ENCLOSURE 1

PROPOSED TECHNICAL SPECIFICATION REVISIONS
BROWNS FERRY NUCLEAR PLANT
UNIT 1, 2, AND 3
(TVA BFNP TS 201 SUPPLEMENT 1)
SECTION 6 - ADMINISTRATIVE CONTROLS

FIGURE 6.2-1

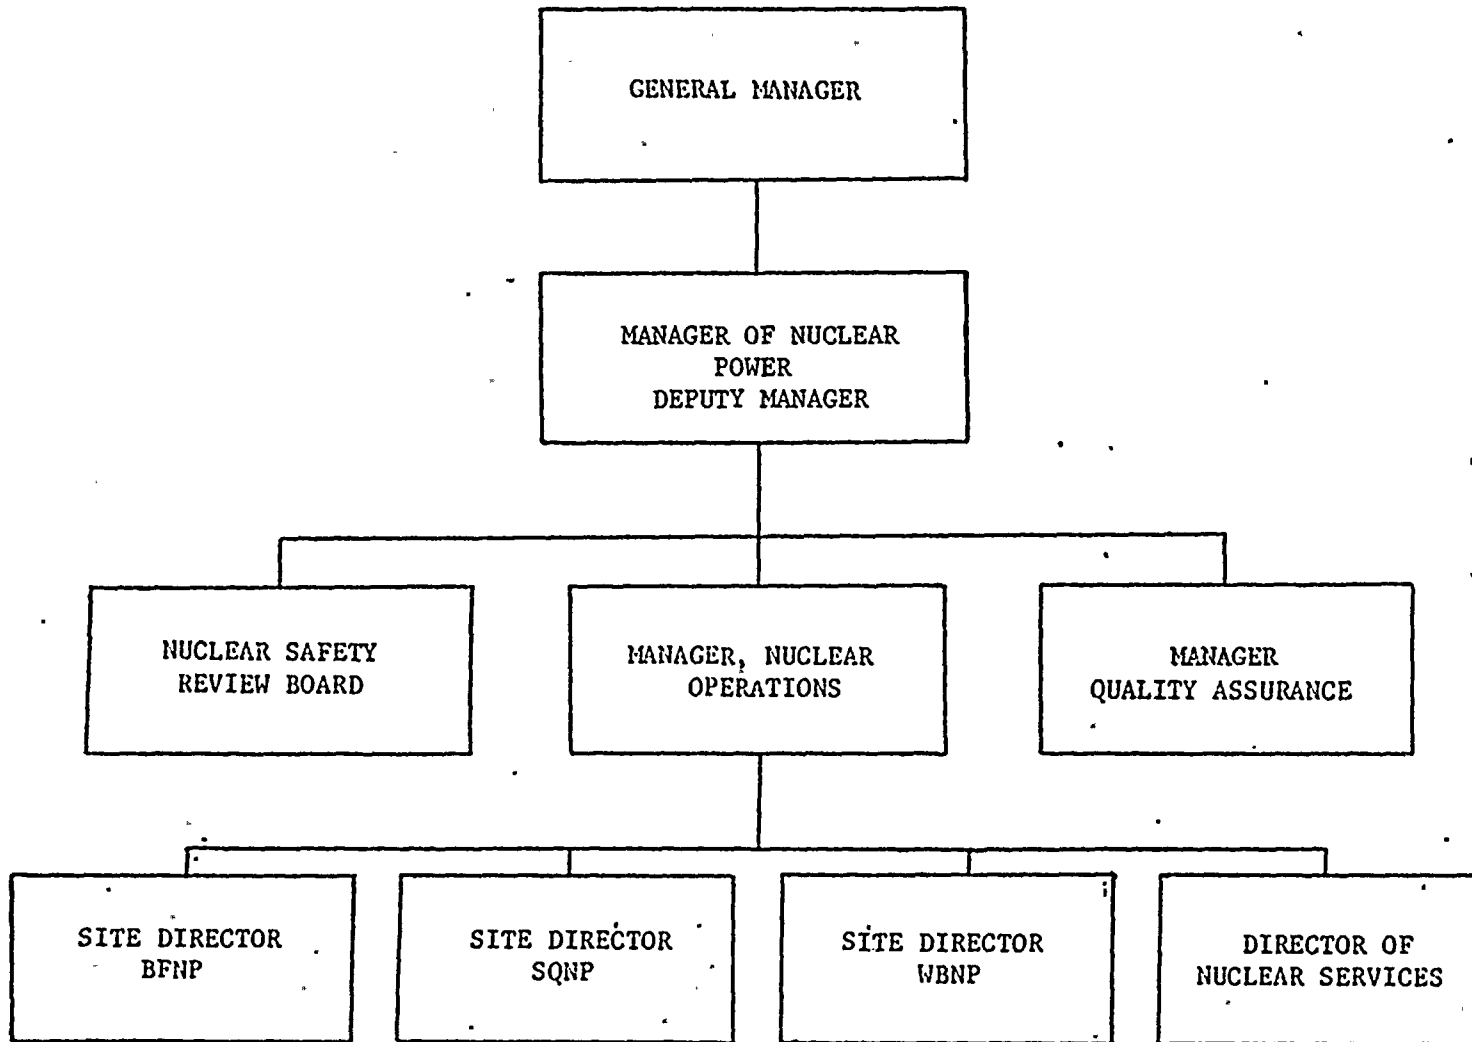
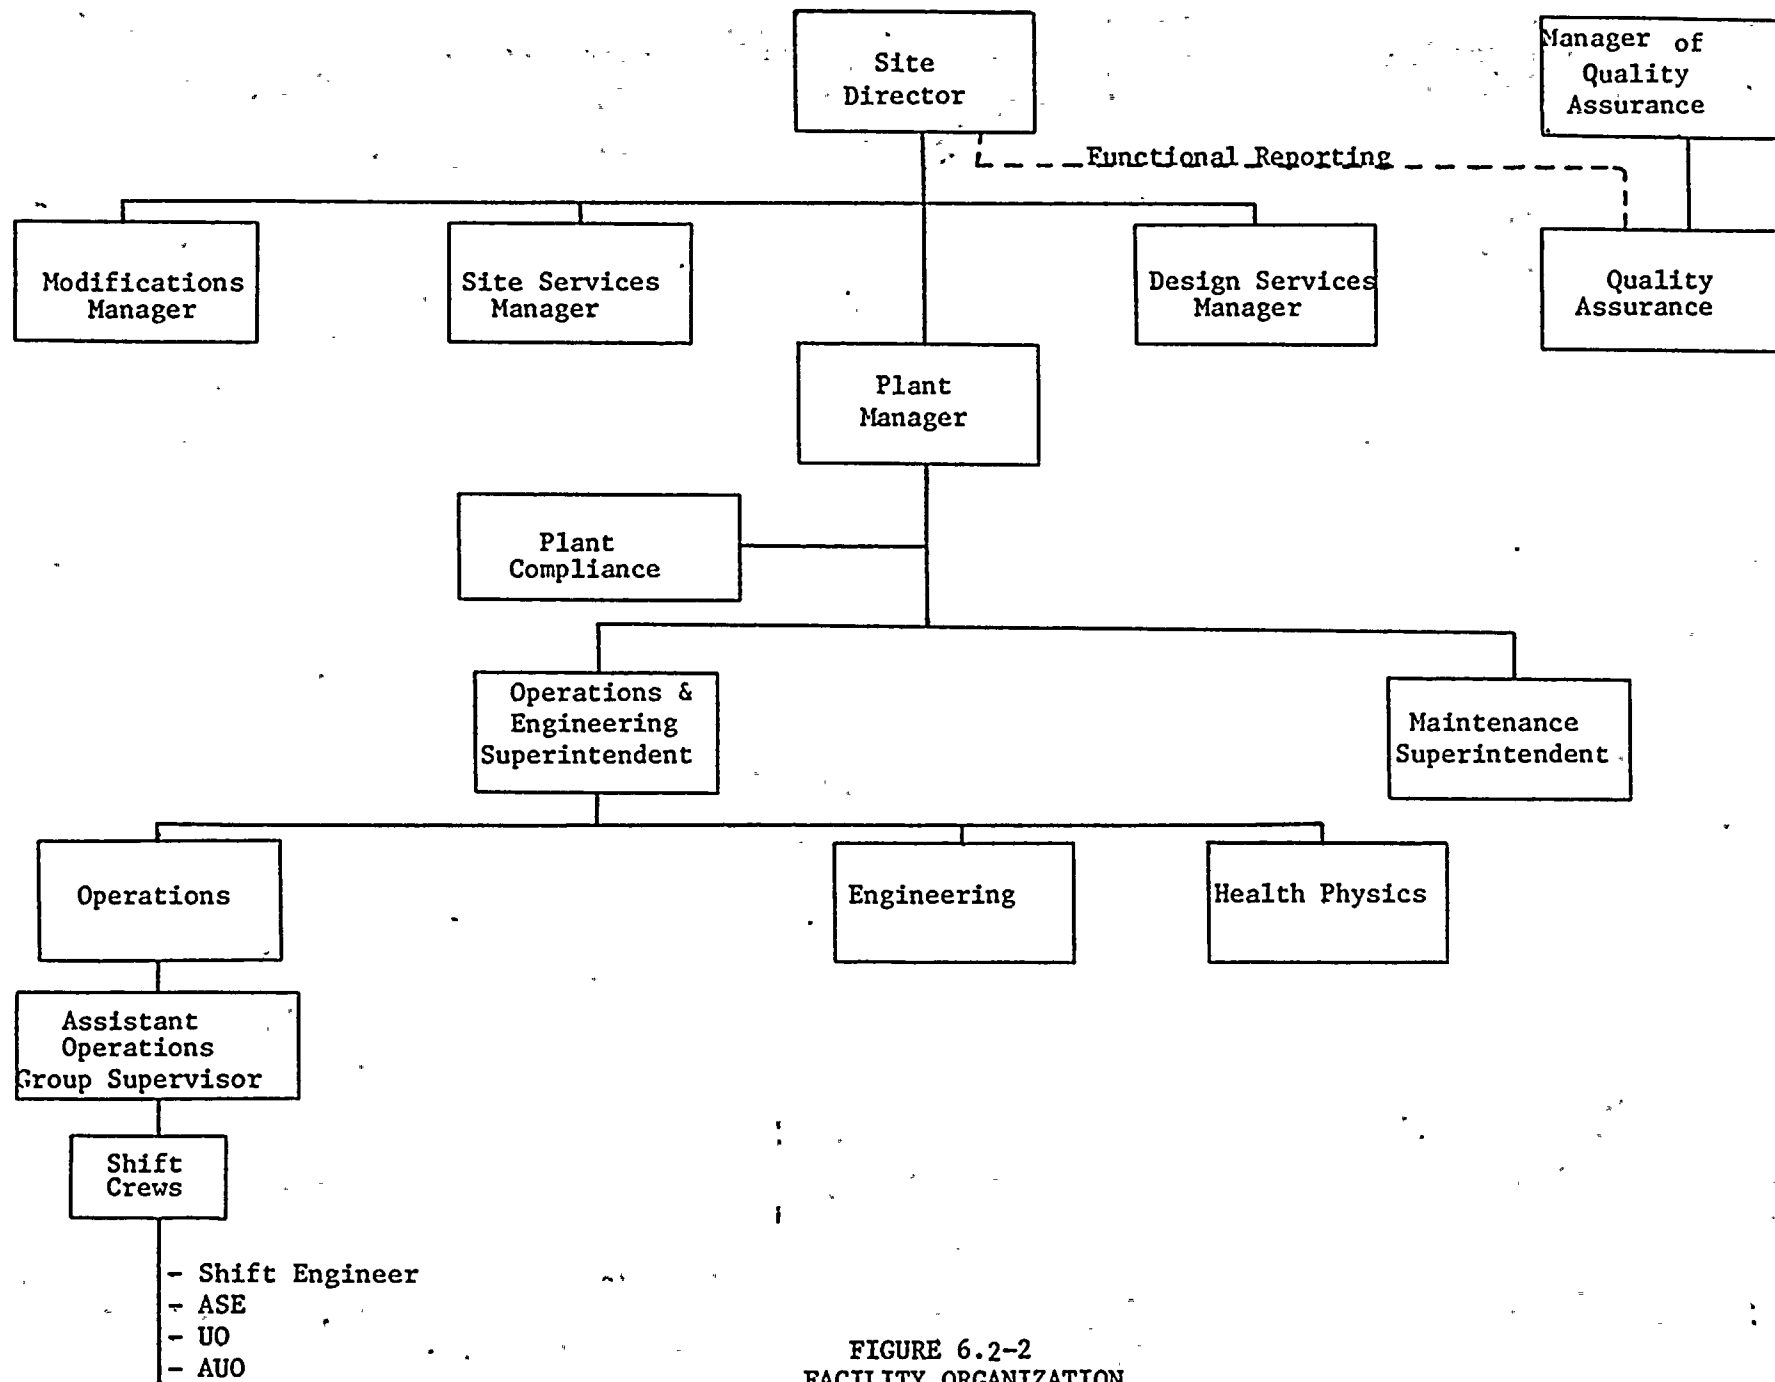
- (10) Pages 6-29 and 6-30 are the revised figures for Offsite Organization and Facility Organization. The "Manager of Nuclear Power" shown on figure 6.2-1 replaced the position of "Manager of Power and Engineering" shown in this figure submitted by TS 201, dated September 27, 1984. TVA request for technical specification change TS 174 and TS 174 Supplement 1, which was superseded by TS 201, this position was shown as the Director, Division of Nuclear Power.

This figure also shows the Nuclear Safety Review Board instead of the Nuclear Safety Staff included in TS 201. The figure shows a change in the structure of Quality Assurance. It also shows the position of Manager, Nuclear Operations..
